Georgia Department of Transportation  
District 7

MSL-0004-00(427), MSL-0004-00(428), and NHS-0001-00(917)  
LEE ROAD/SWEETWATER ROAD WIDENING - PHASE 1, CR 817  
LEE ROAD WIDENING - PHASE 2  
I-20/LEE ROAD INTERCHANGE RECONSTRUCTION  
P. I. Nos. 0004427, 0004428, and 0001917  
Douglas County, Georgia

## Value Engineering Study Report Preliminary Design Phase

January 2007

DESCRIPTION: **PROVIDE ACCESS TO THE NEW FIRE STATION AT THE  
 INTERSECTION OF GROOVERS LAKE ROAD AND LINDA DRIVE**

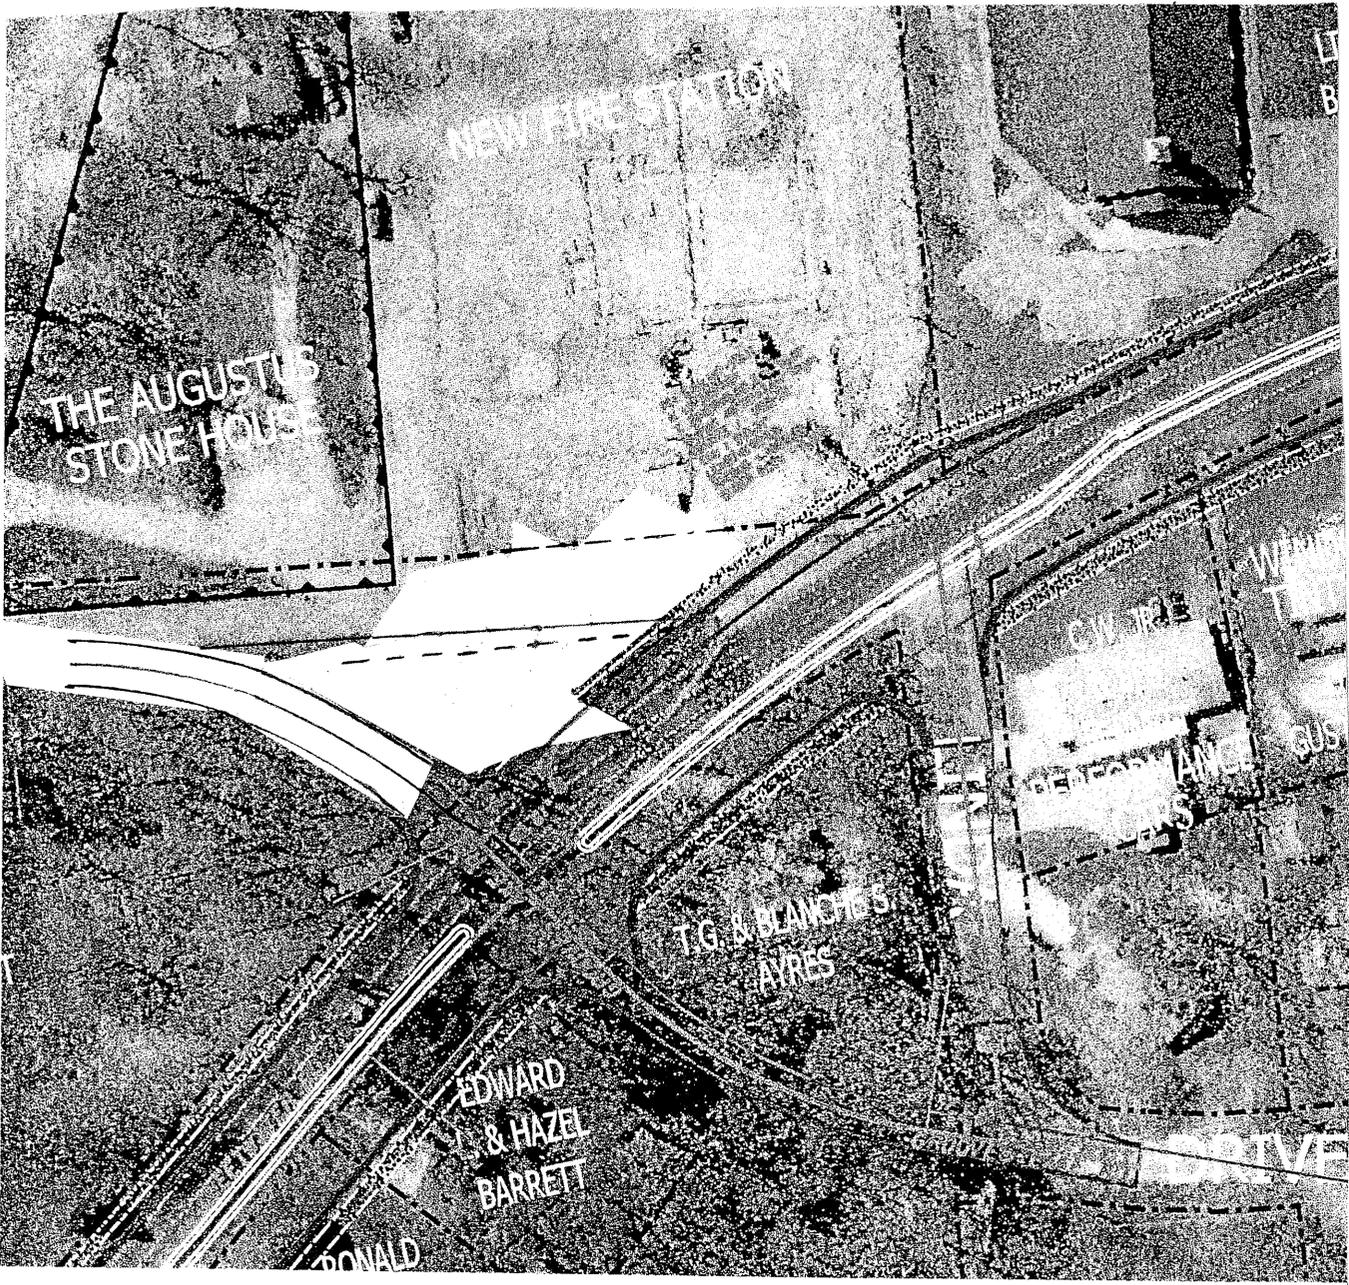
Provide access to the new fire station onto Groovers Lake Road adjacent to the new Lee Road/Groovers Lake Road/Linda Drive intersection.

The new fire station was recently constructed and has not yet been commissioned. When the current design documents were produced, the required access had not been incorporated into the design. Although increasing the initial cost of the project, the overall benefits associated with rapid emergency vehicle responses outweigh the added costs.

Due to the location of the proposed emergency intersection, a traffic control device may be required and has been included in the costs below.

PH2-4

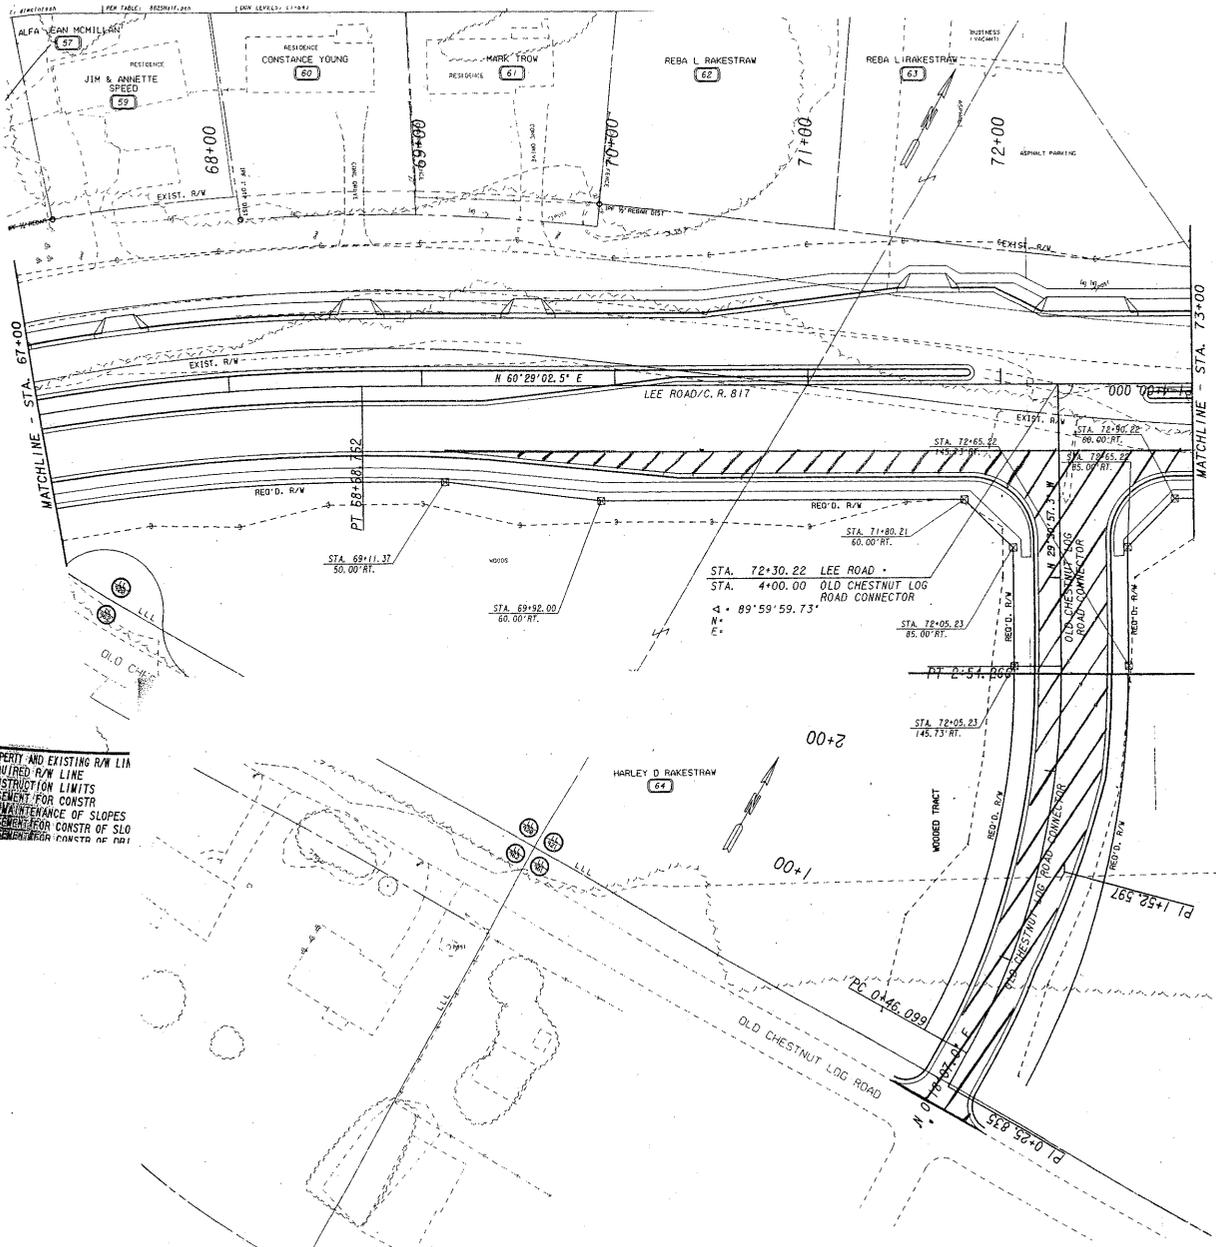
Realizing the added burden on the local streets and increased traffic volumes in residential areas, this alternative improves the safety aspects of accessing Lee Road. Although not calculated as part of the savings, the local roads may have to be upgraded in the future. It is noted, however, that the local roads are already heavily used by traffic cutting through neighborhoods.

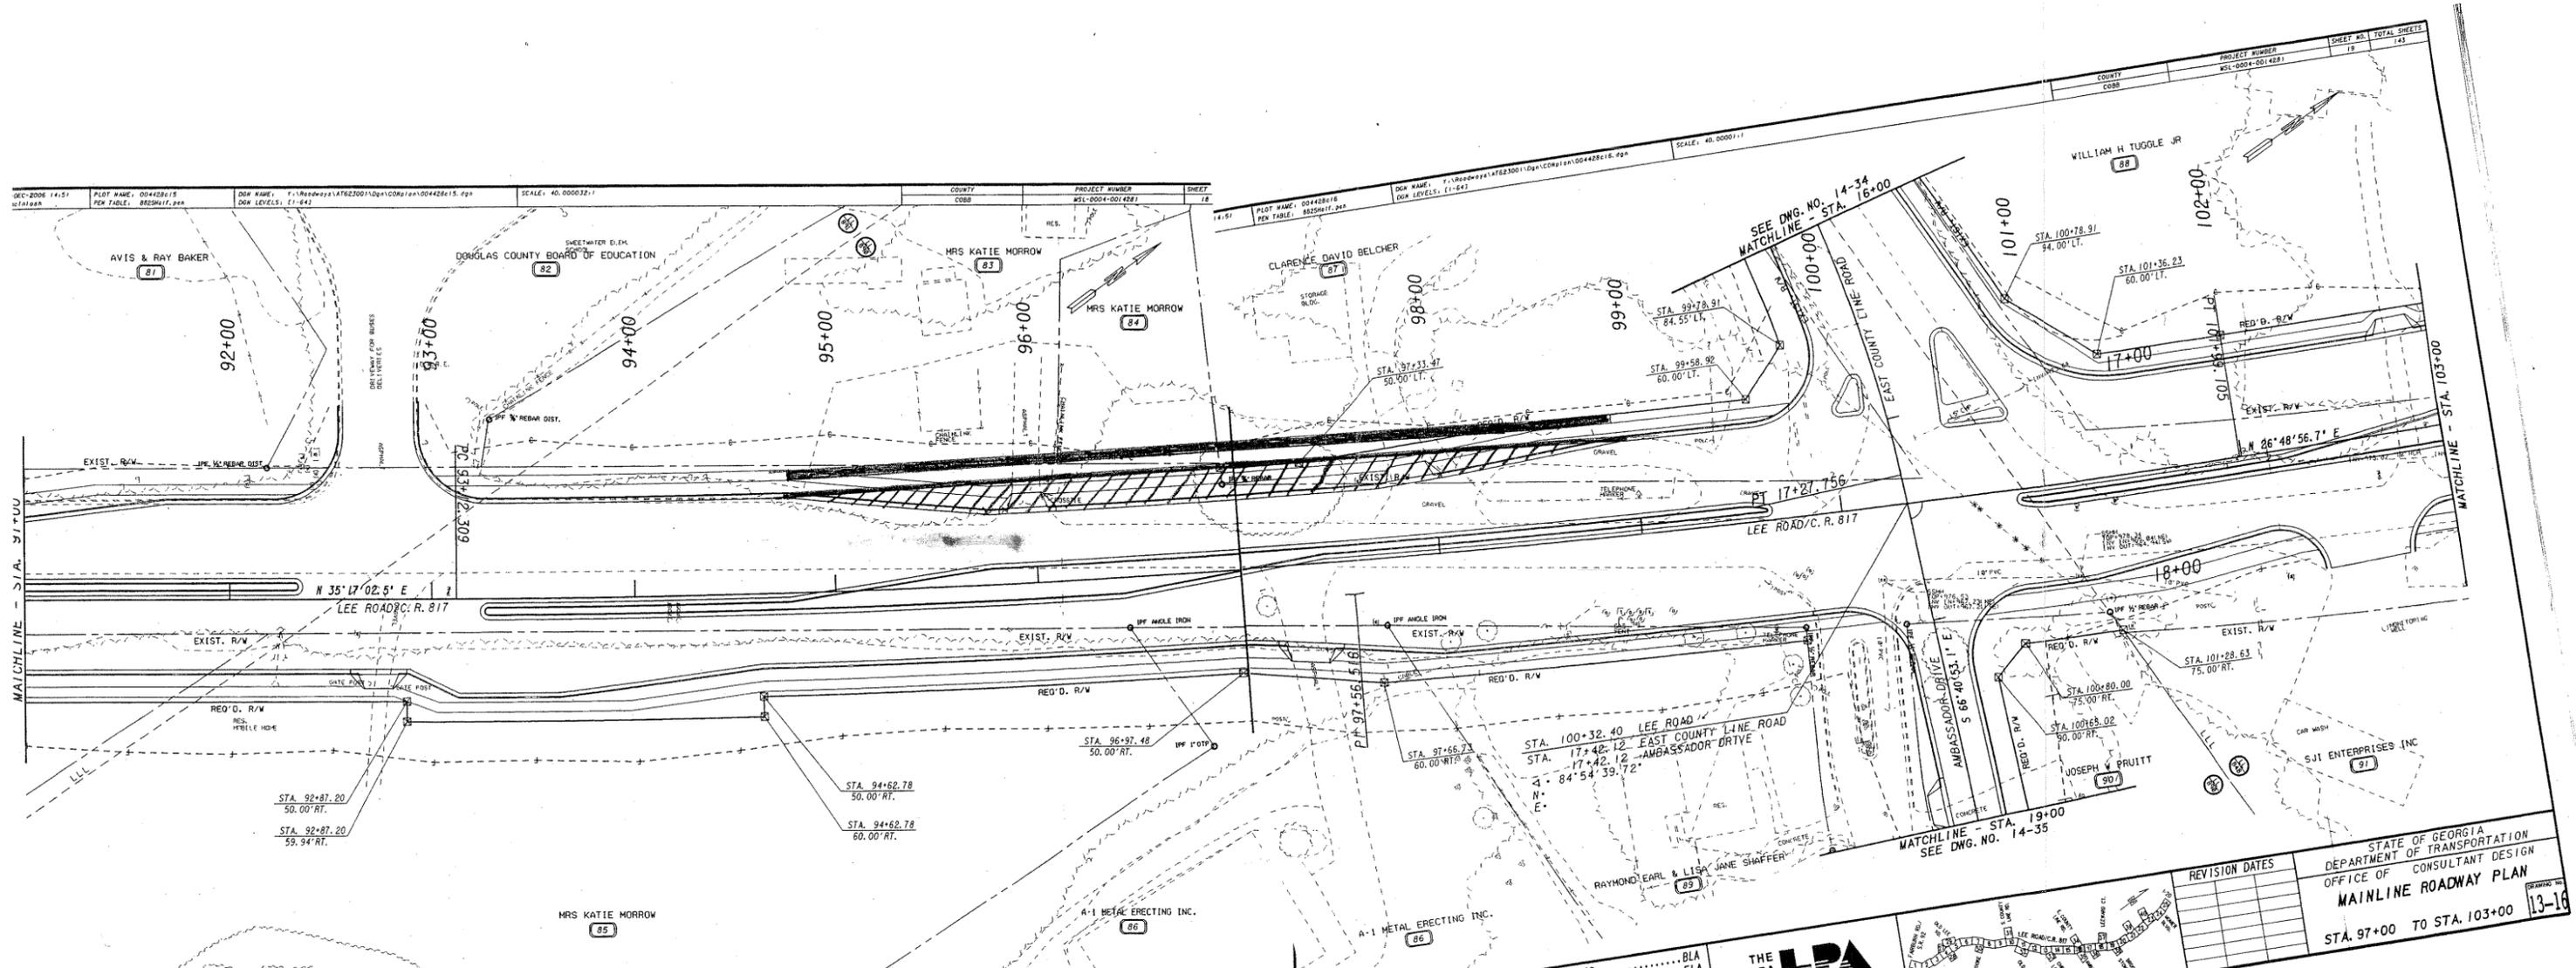
- Improves safety for school buses
- Improves traffic flow
- Adds benefit/value

PH2-11

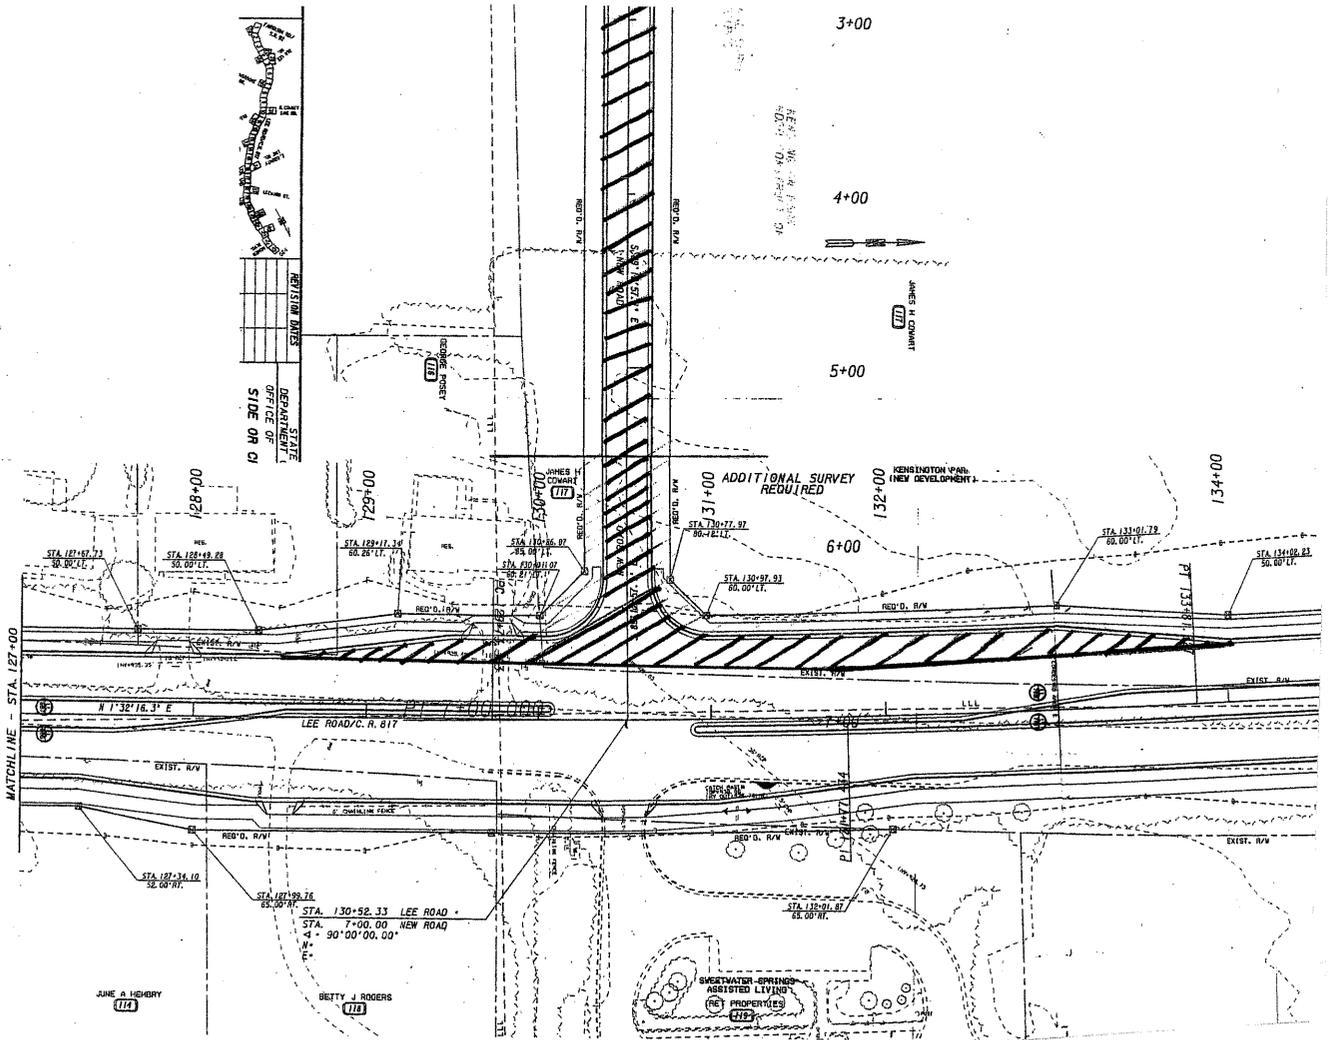
Eliminate the “New Road” construction from this contract and have the developer provide this access to Lee Road in the future.

The current design indicates the “New Road” leading to a wooded tract of land with no apparent improvements. If the land is to be developed in the future, do not burden this project with the cost of an uncertain benefit; instead, have the future developer provide access to Lee Road. The costs associated with the “New Road” should be part of the development costs and passed onto the ultimate users, not the taxpayers.
